84

SEQUOYAH NUCLEAR PLANT (SQN) - RESPONSE TO REQUEST FOR
ADDITIONAL INFORMATION (RAI) REGARDING CODE RELIEF REQUEST
INSERVICE INSPECTION (ISI)-15

RESPONSE TO REQUEST FOR ADDITIONAL INFORMATION REGARDING CODE RELIEF REQUEST ISI-15

Figure 1

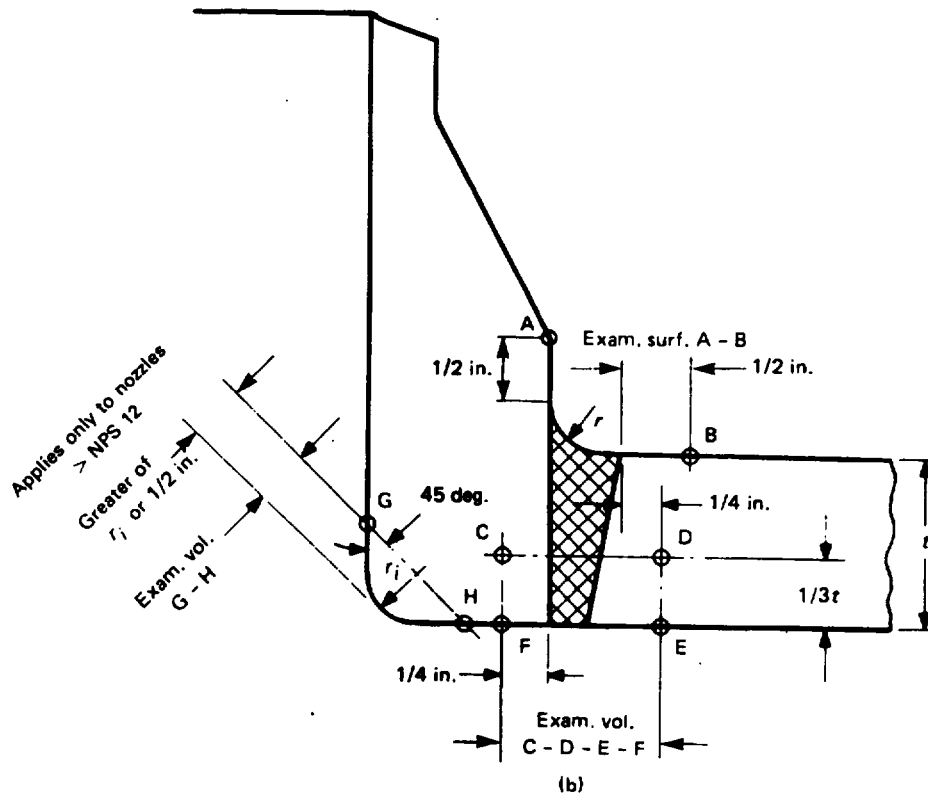
ASME Section XI, 1989 Edition, Table IWC-2500-1, Examination Category C-B, Item Number C2.22, requires a Volumetric Examination. The examination requirements from Table IWC-2500-1 specify Figure No. IWC-2500-4(a) or (b). The figure that most closely resembles the SQN RHR Heat Exchanger is Figure IWC-2500-4 (b). The examination volume indicated for the inner radius examination is area G-H. The actual SQN RHR Heat Exchanger nozzle configuration does not indicate a radius; therefore, the examination volume is a ½-inch region as indicated in Figure 1.

Figure IWC-2500-4 (b) indicates the required flaw orientation to be radial/axial, therefore, two circumferential scans, one clockwise and one counterclockwise, are required to examine the examination volume as indicated in Figure 1. The transducer angle and skew must be optimized to impinge the flaw at the correct orientation.

Figure 4. Combined Coverage of Boss Procedures, 46/90 and 62/140 and Vessel Procedure, 70/22-38 for Sequoyah RHR Heat Exchanger Nozzle (N1 & N2).

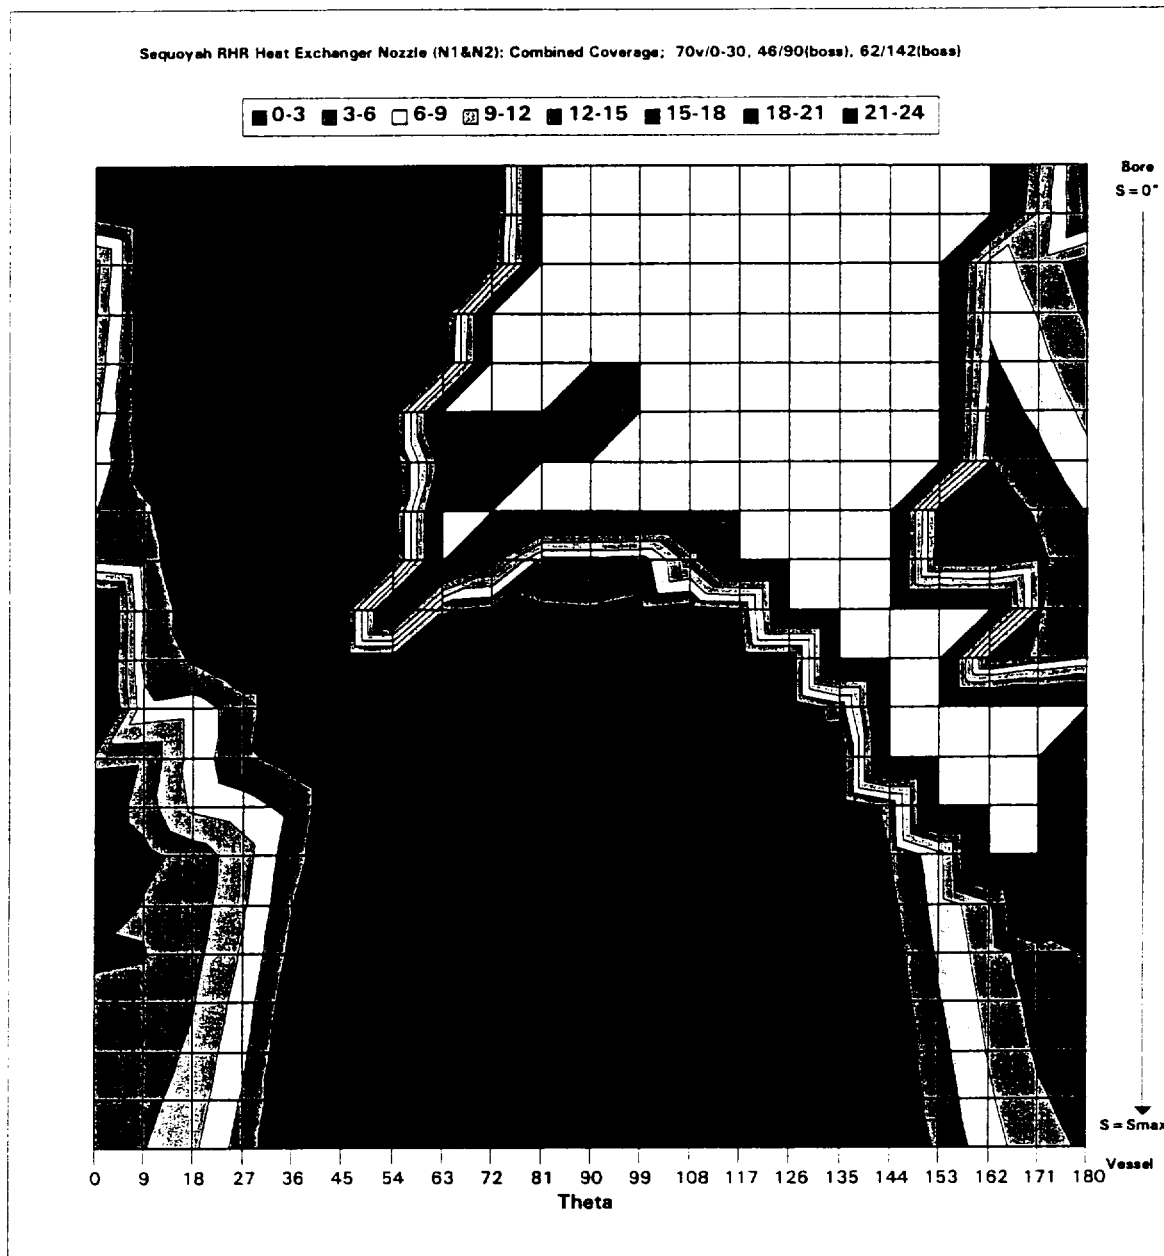
The Electric Power Research Institute report attached to the submittal states that 82 percent coverage is achievable for the inner nozzle radius using 46° beam angle skewed 90°, 62° beam angle skewed 140°, and 70° beam angle skewed 22-38°. Explain why this coverage is considered unacceptable. Discuss the difficulty associated with ultrasonic examination (not discussed above) of this specific nozzle (inner radius).

The coverage determination provided in the EPRI report only refers to the "best effort" inspection parameters for the RHR nozzle geometry. It does not refer to coverage with an effective procedure.

The purpose of the coverage maps in the EPRI report was to illustrate the optimum beam angles, transducer skew, and probe position which would deliver the lowest misorientation

at the nozzle inner radius surface. As discussed in the EPRI report, signals returned from the reflectors could not be resolved from the general material noise, even after the reflector was increased from 10 percent to 30 percent of the wall thickness.
